DOCUMENT CHANGE NOTICE (DCN)

DOCUMENT No. (DOC-REV-GP. ID)	TITLE	NEW REV.
D970004-A-D	Core Optic Component Carrier Expansion Plug Installation Tool	B

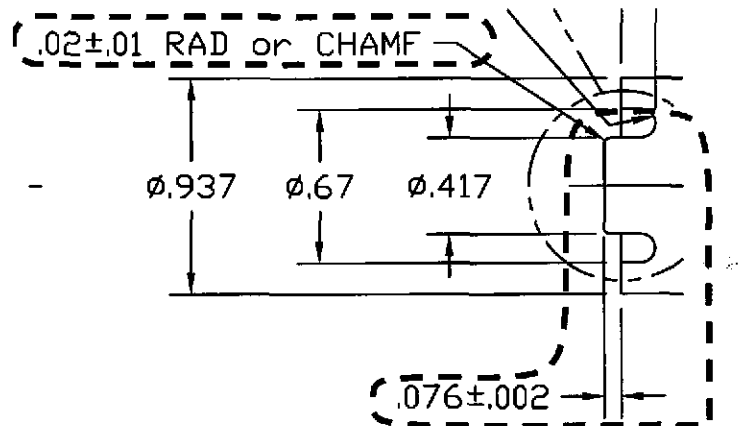
CHANGE DESCRIPTION (FROM/TO):

FROM:

TO:

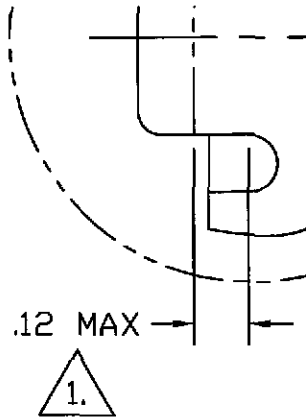
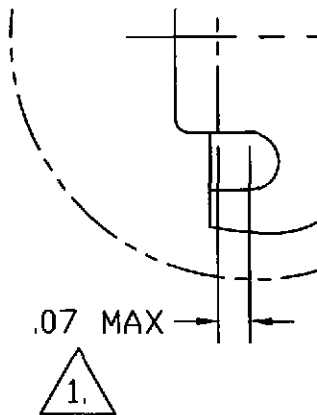
FROM:

TO:

REASON FOR CHANGE:

Protrusion distance of cylindrical feature from shoulder was not correct.
